ADDENDUM NO. 2
TO
PLANS, SPECIFICATIONS
AND
CONTRACT DOCUMENTS
FOR

CITY OF MANTECA
WASTEWATER QUALITY CONTROL FACILITY

WQCF RECLAIMED WATER IMPROVEMENTS PROJECT

October 2016

JOB NO.
2015-113 T01
 DRAWING NO.
M10-4-A2
 SHEET NO.
28 OF 62

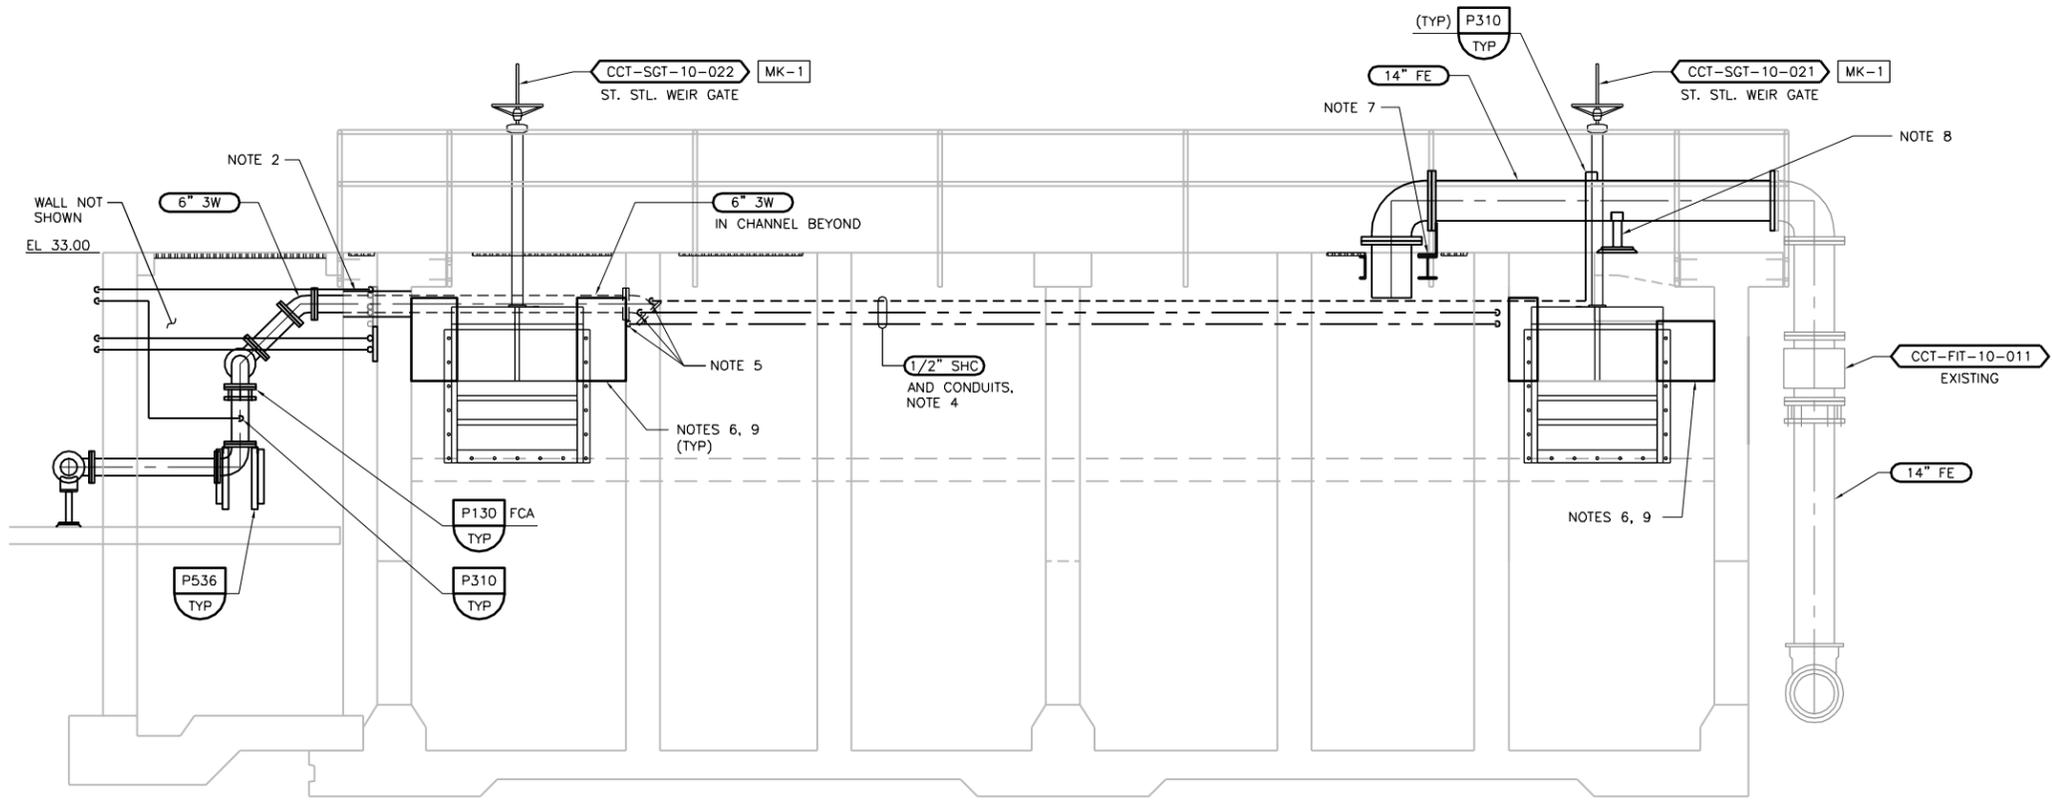
1. Add the additional existing east most penetration through the center basin wall in the same location as the new east most penetration on the attached Drawing M10-4-A2.

1. Add the additional existing east most penetration through the center basin wall in the same location as the new east most penetration on the attached Drawing M10-4-A2.

2. Add a new slide gate, and a callout reading "CCT-SGT-10-023" similar to the east most penetration and slide gate shown on the attached Drawing M10-4-A2.

1. Replace Drawing M10-4 with the attached Drawing M10-4-A2.

JOB NO.
2015-113 T01
 DRAWING NO.
M10-6-A2
 SHEET NO.
30 OF 62

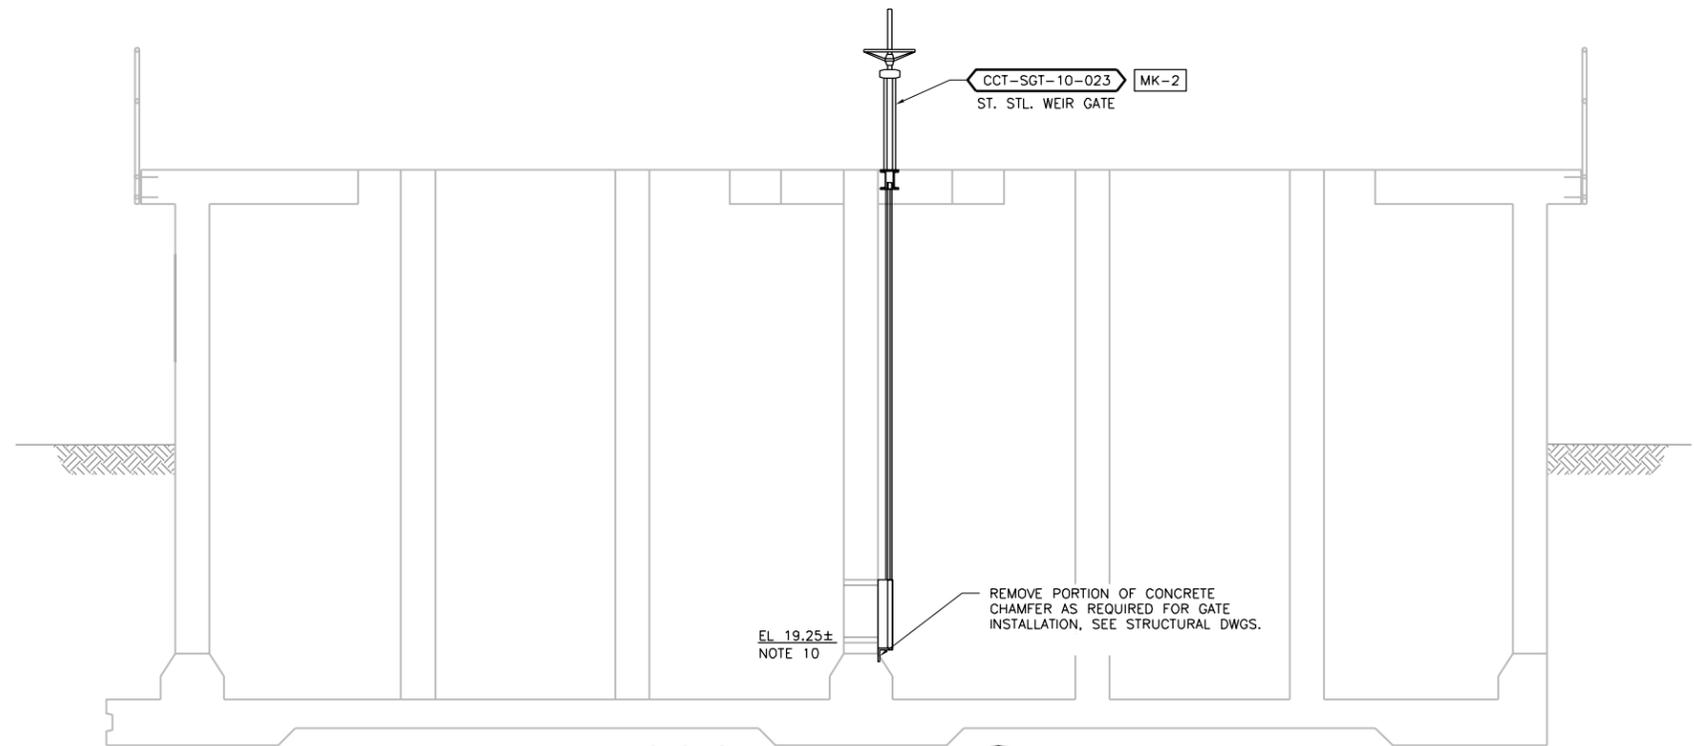
1. Replace Drawing M10-6 with the attached Drawing M10-6-A2.
